TO: Keith Fronczak, Boulder Associates
FROM: Stacey Nerger, Senior Planner
DATE: October 30, 2024
SUBJECT: Crown Point Filing No. 1 Amendment 30 Lot 1– Site Plan Review Comments 03

SITE PLAN

ADVENTHEALTH PARKER FACILITY EXPANSION

DESCRIPTION	DATE
1ST SUBMITTAL	06/03/2024
2ND SUBMITTAL	08/16/2024
3RD SUBMITTAL	10/10/2024

DATE 08/16/2024
PARKER PROJECT NUMBER SP24-062
SHEET TITLE
OVERALL LANDSCAPE PLAN
DRAWING NUMBER

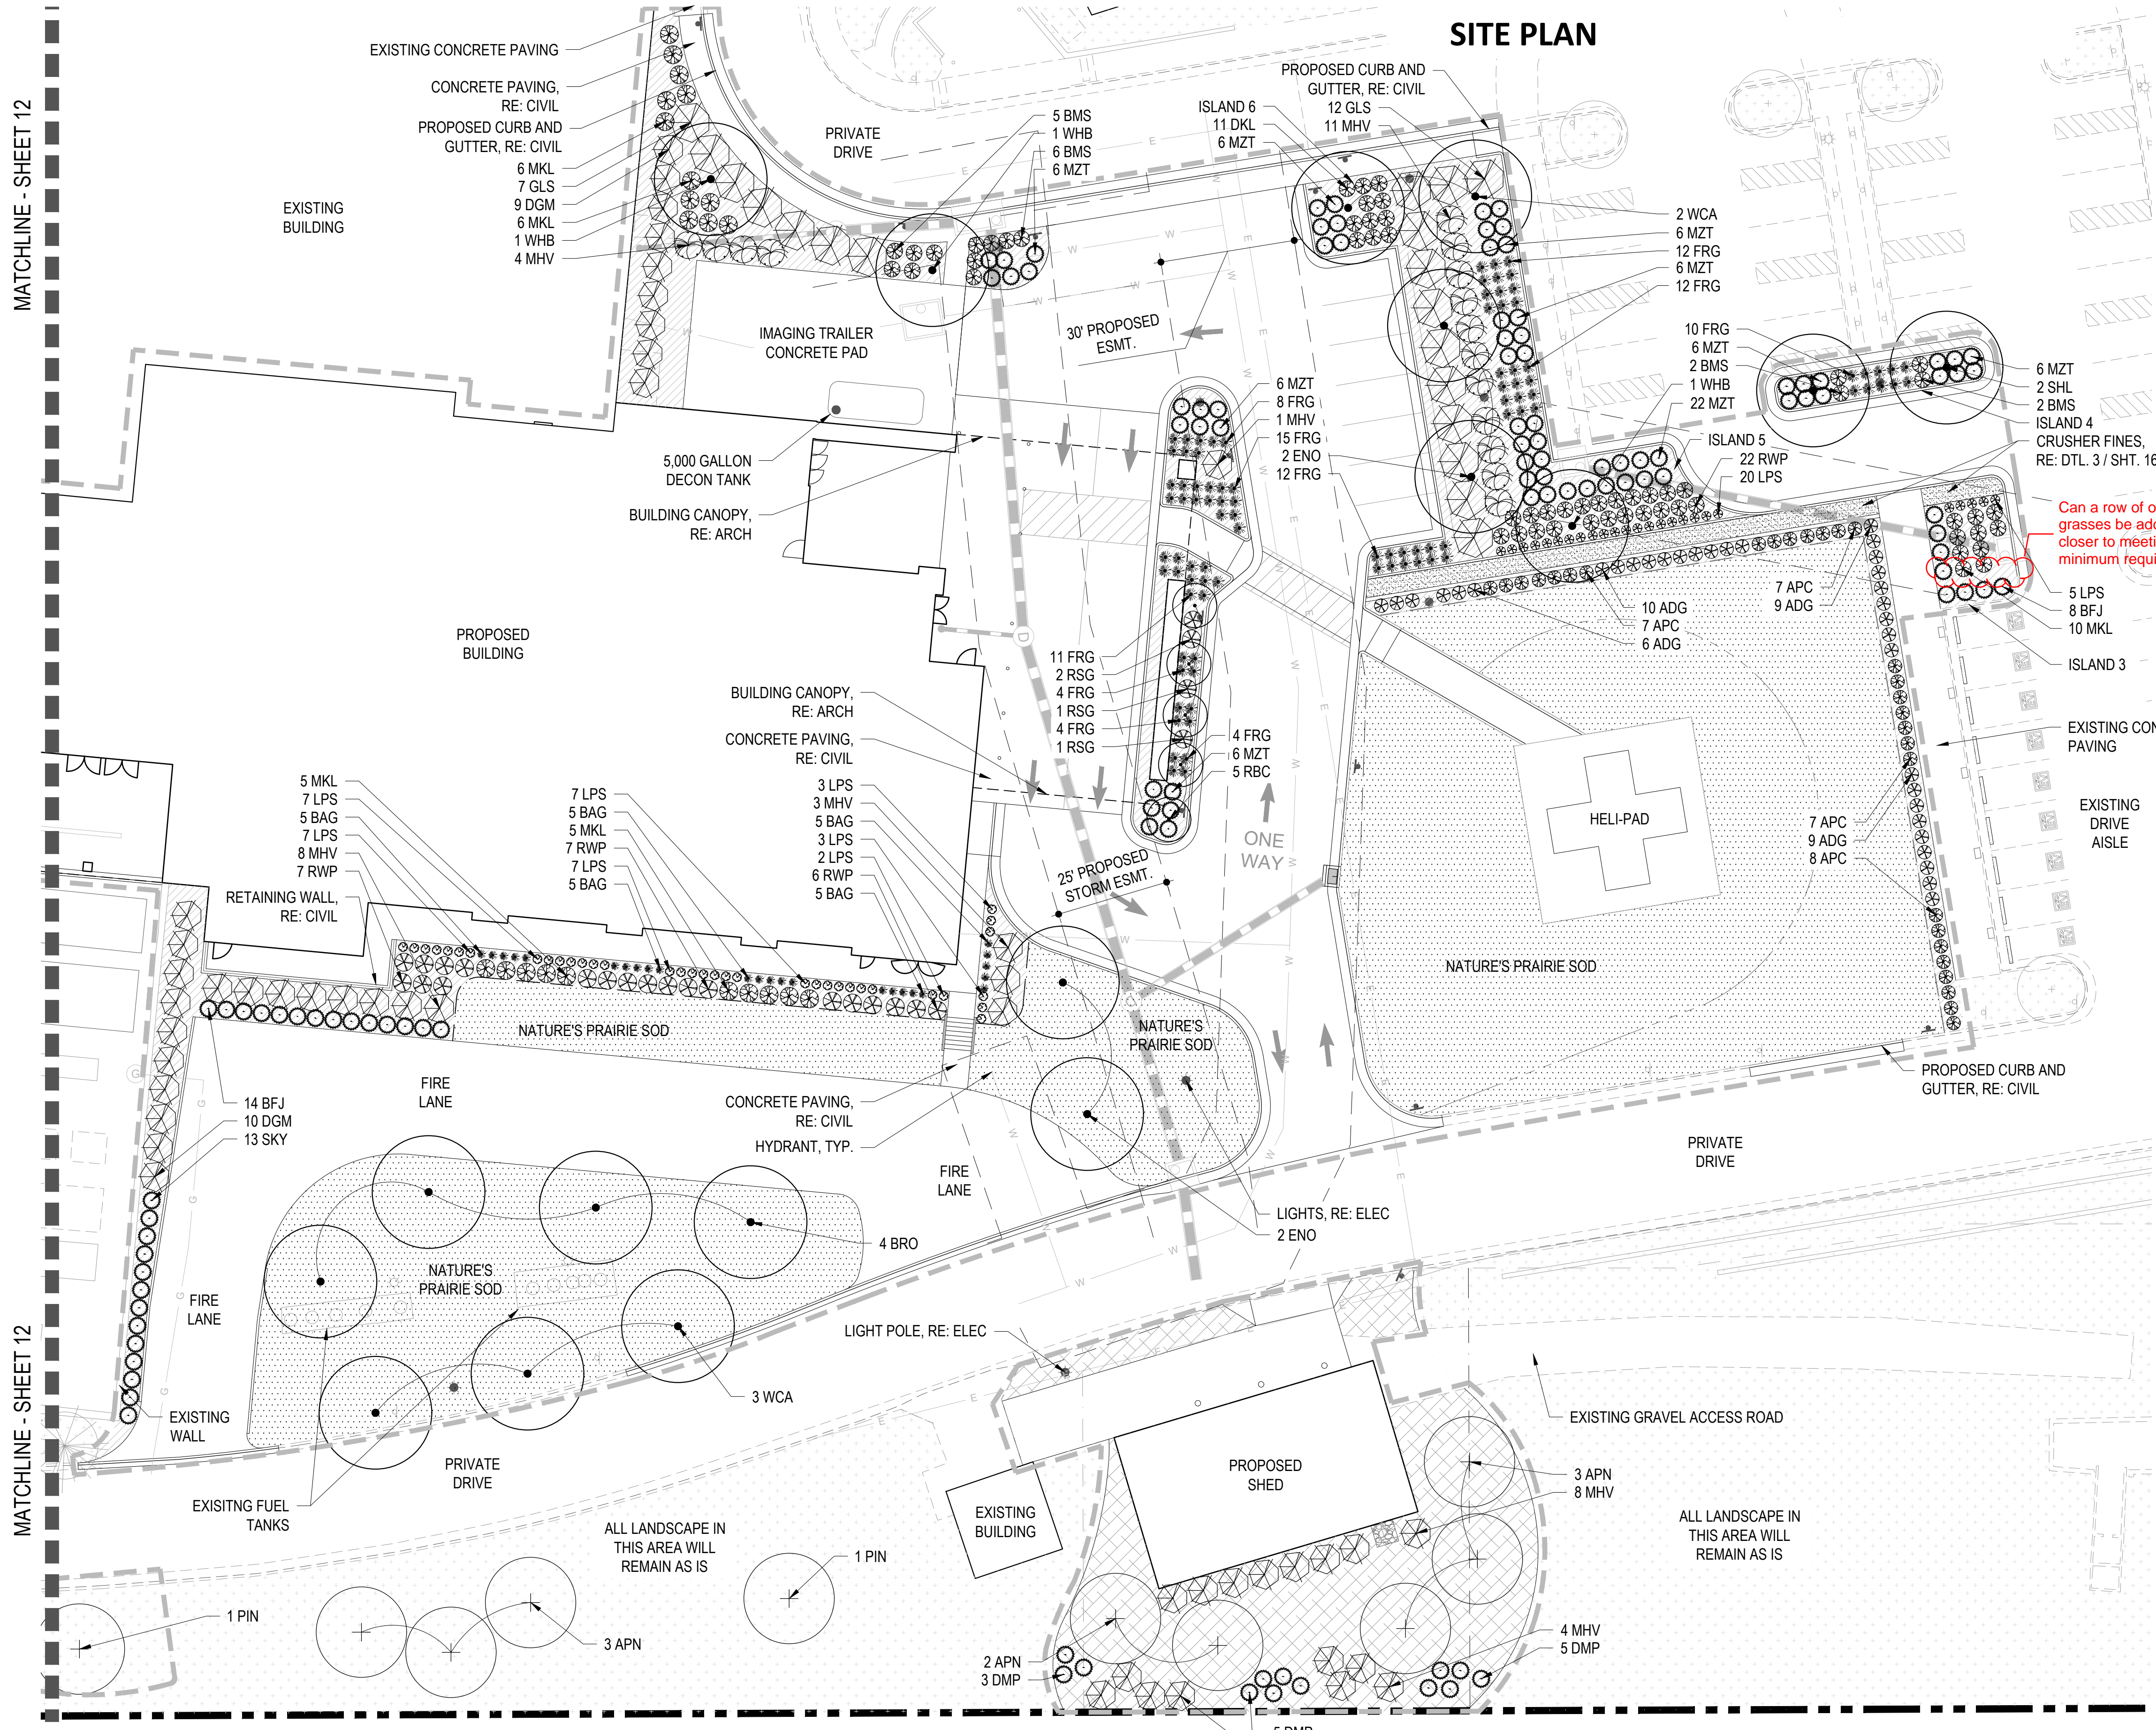
Please add a note as to why this island does not meet the minimum requirements. Stormwater and no trees permitted is an ok response.

Rename this table to :
Proposed landscape

This number does not match the number on the first page.

Please add the following information to this page:

Existing landscaping 385,781
Removed landscape 30,978
Total landscape proposed 327,803
Landscape required (1,474,205 SF * 15% = 221,131 SF)

Ornamental grasses equal shrubs at 3 grasses equal 1 shrub.

Why don't these two number match?

Please include an additional column for the ornamental grasses proposed.

Staff only counts 52 shrubs.

SHEET TITLE
**ARCHITECTURAL
SITE PLAN**

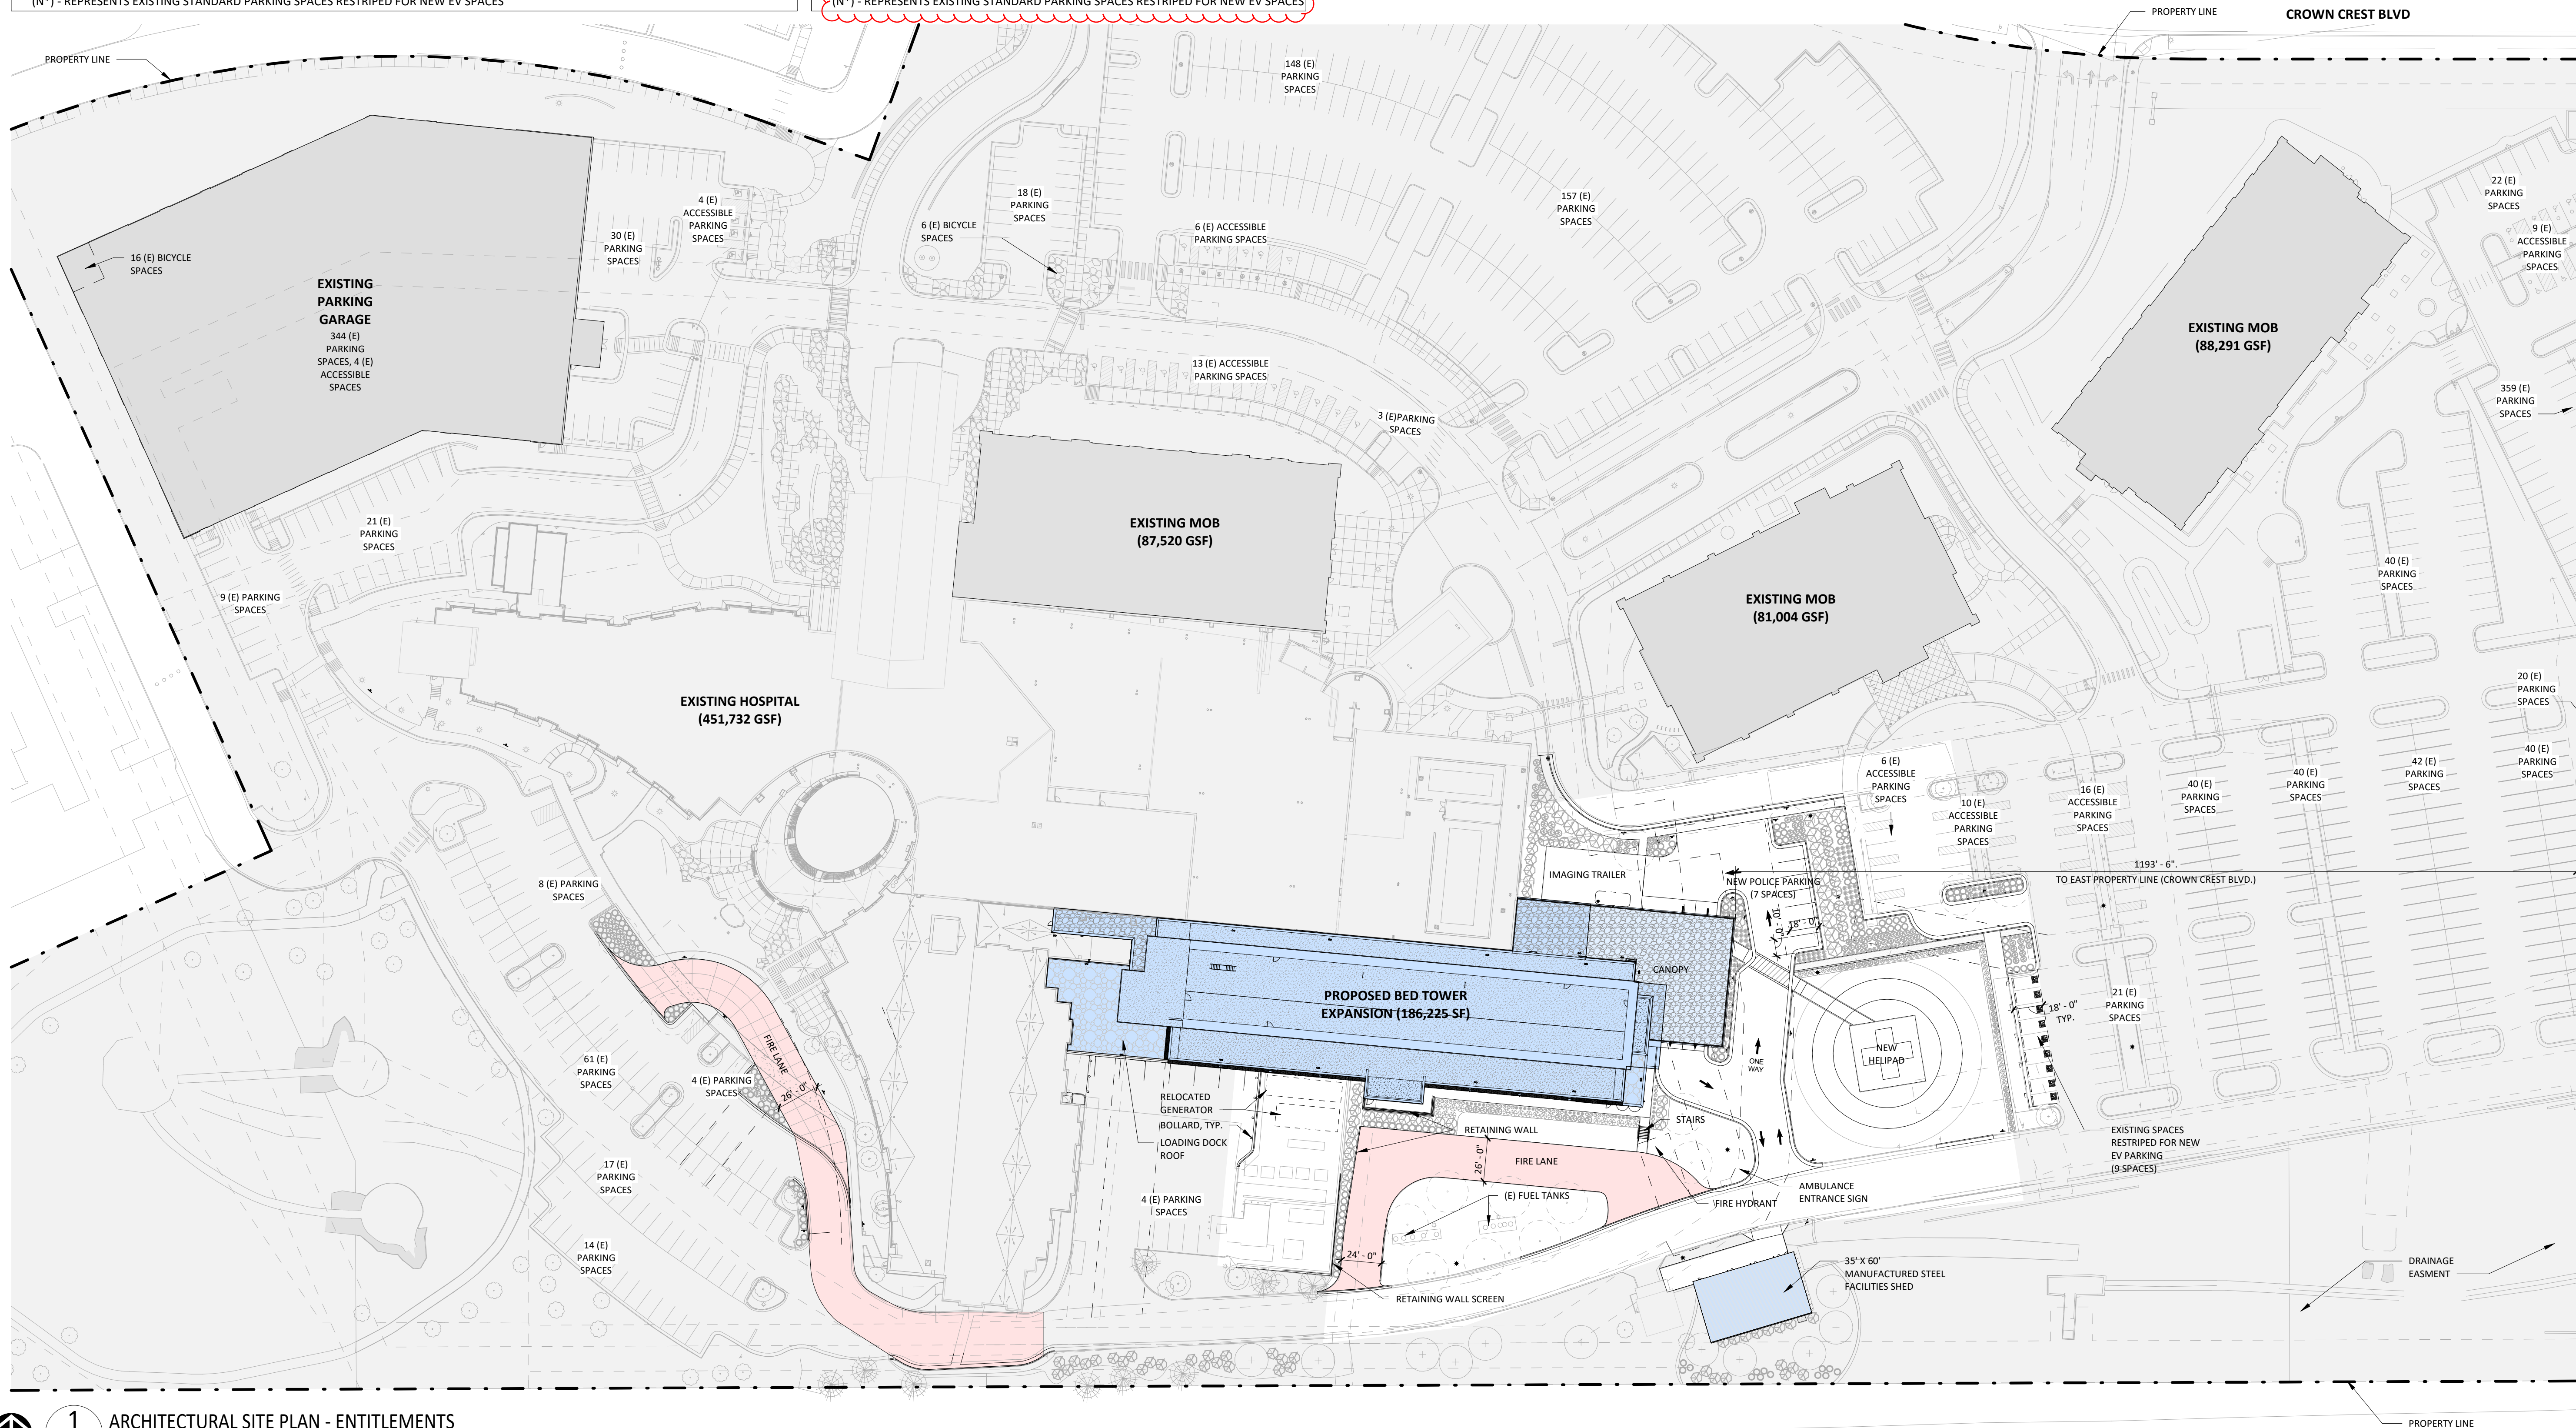
Please add these symbols to the site plan below for where these spaces are located.

SHEET TITLE
**EXTERIOR
ELEVATIONS**

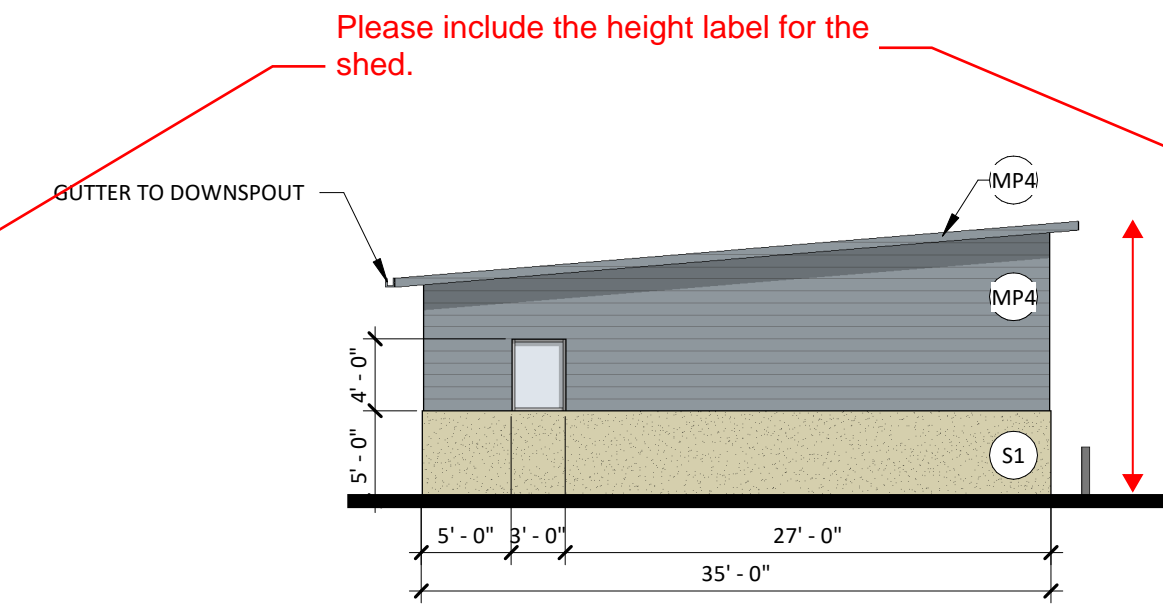
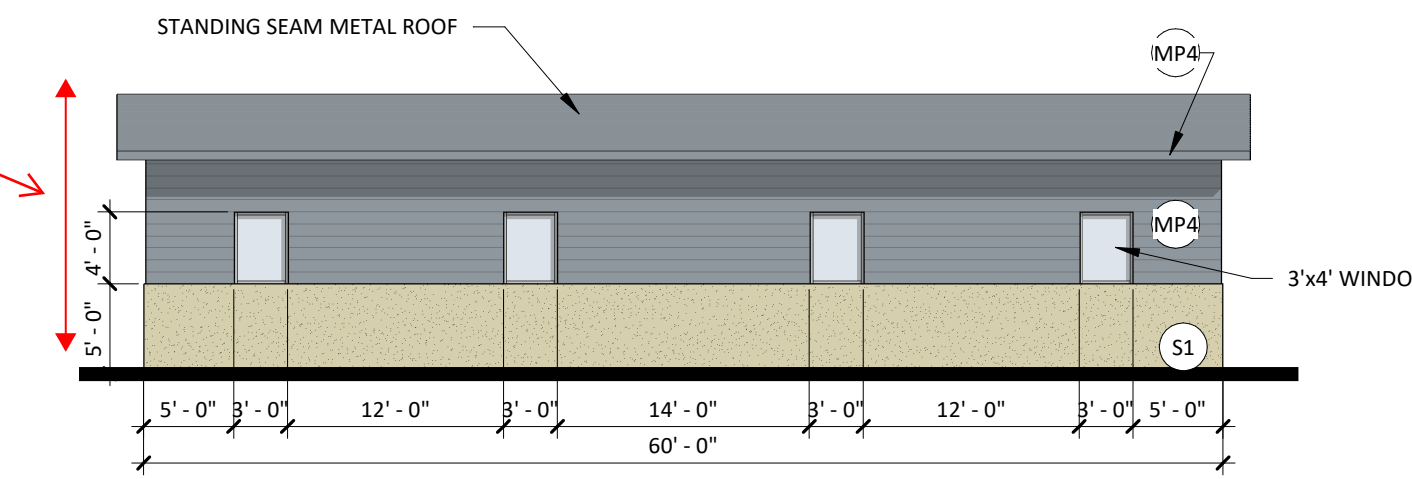
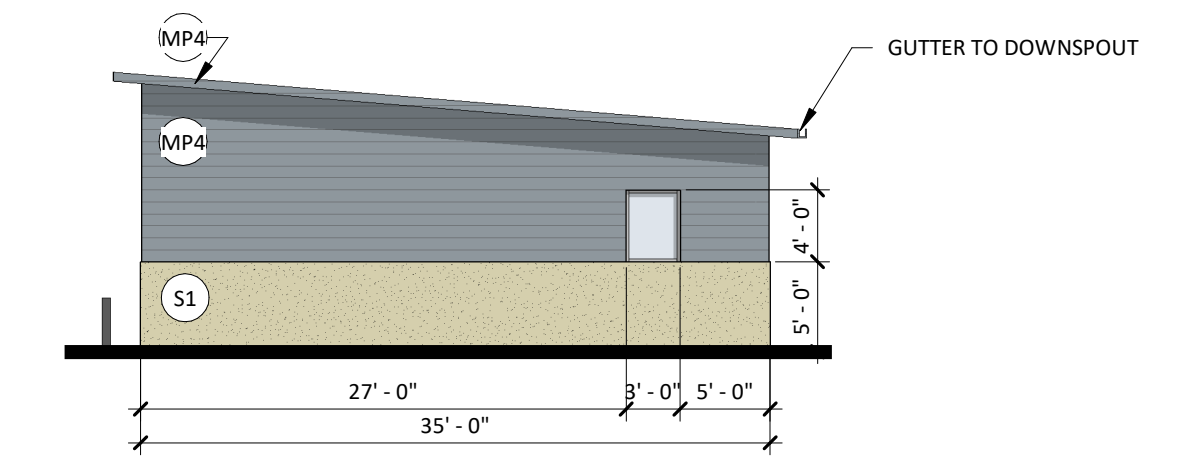
Please add an image of the metal screening proposed to be used to screen the storage yard.
